Traffic Calming (Speed Humps) - Sedgemount Drive

Date: September 3, 2025

From: Director, Enforcement and Street Management, Transportation Services

Attachment 3: Speed Hump Locations Plan - Sedgemount Drive - Pandora Circle (southwest intersection) - Pandora Circle (northeast intersection) (Matchline, see drawing TC-557)

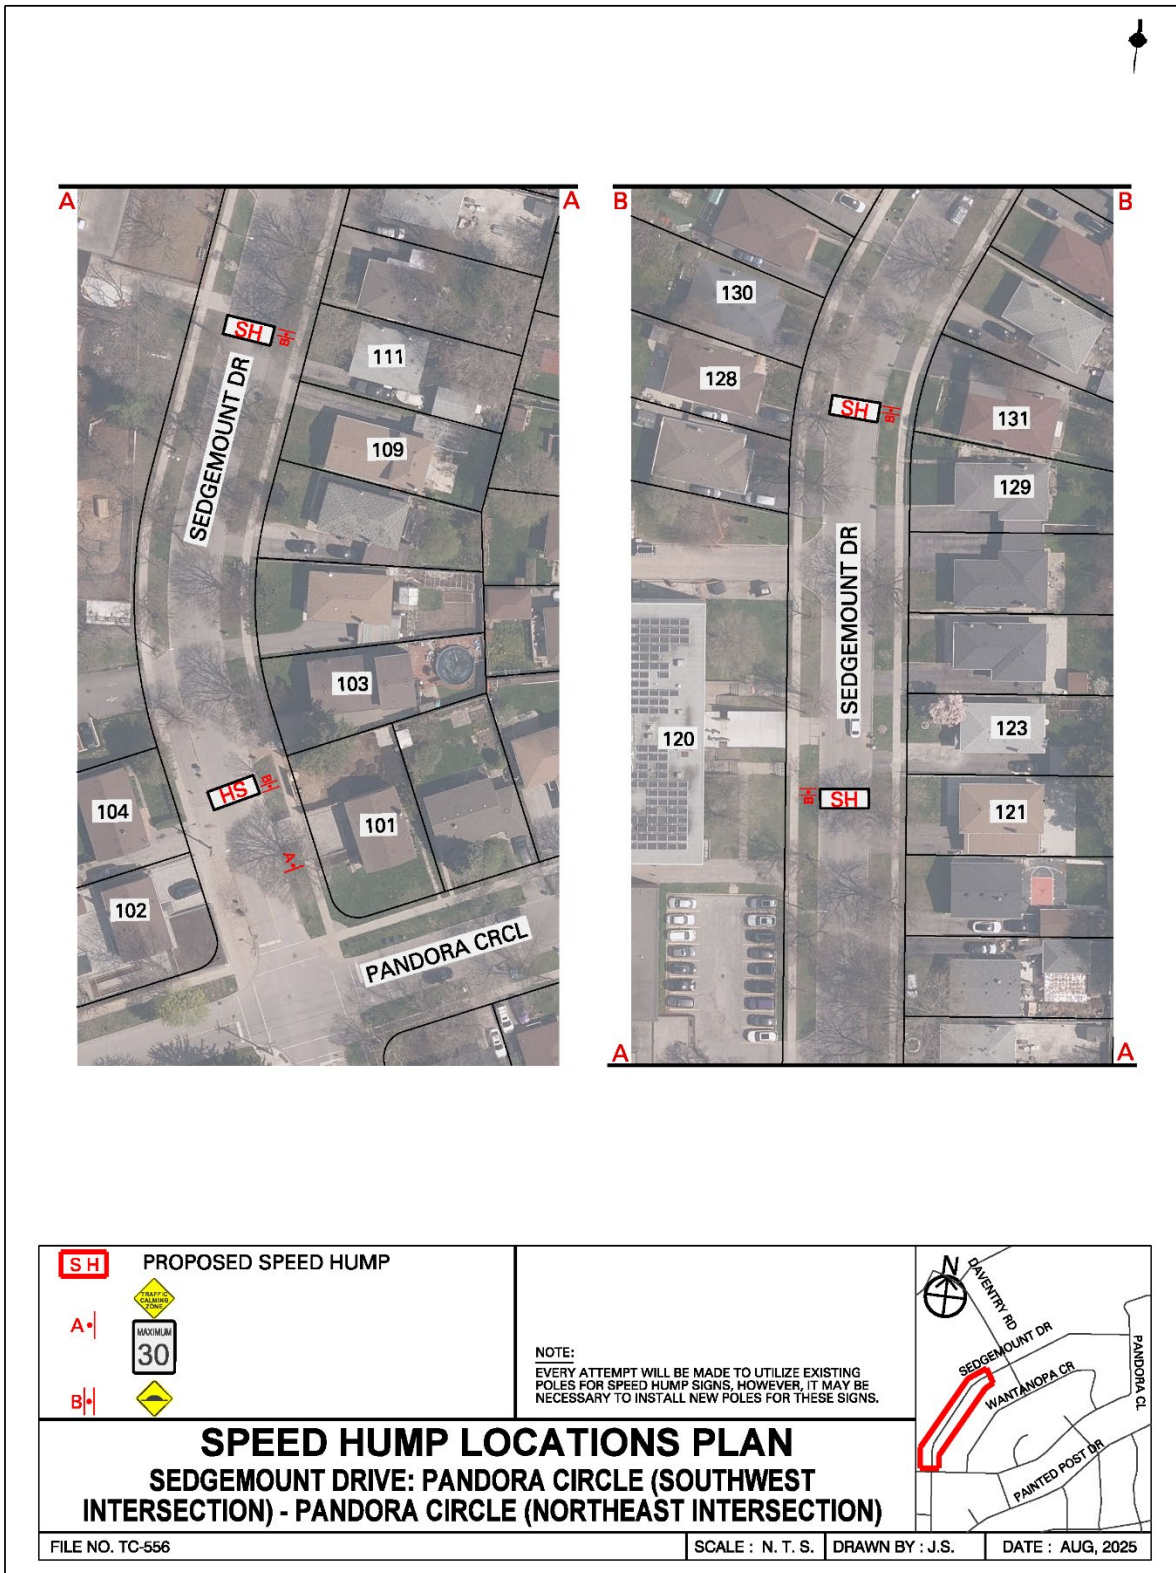
We have received and reviewed the proposal for installation of speed humps on Sedgemount Drive, between Pandora Circle (southwest intersection) and Pandora Circle (northeast intersection), with the following comments:

The installation of speed humps on Sedgemount Drive, between Pandora Circle (southwest intersection) and Pandora Circle (northeast intersection), will impact response and transport times for residents that reside on the roadway speed humps are installed. Impacts may extend to community members if Sedgemount Drive, between Pandora Circle (southwest intersection) and Pandora Circle (northeast intersection), serves access to other roadways. It is important that the applicant understands that the installation of traffic calming devices will reduce the speed that emergency vehicles travel when responding to emergencies on roadways where they are installed.
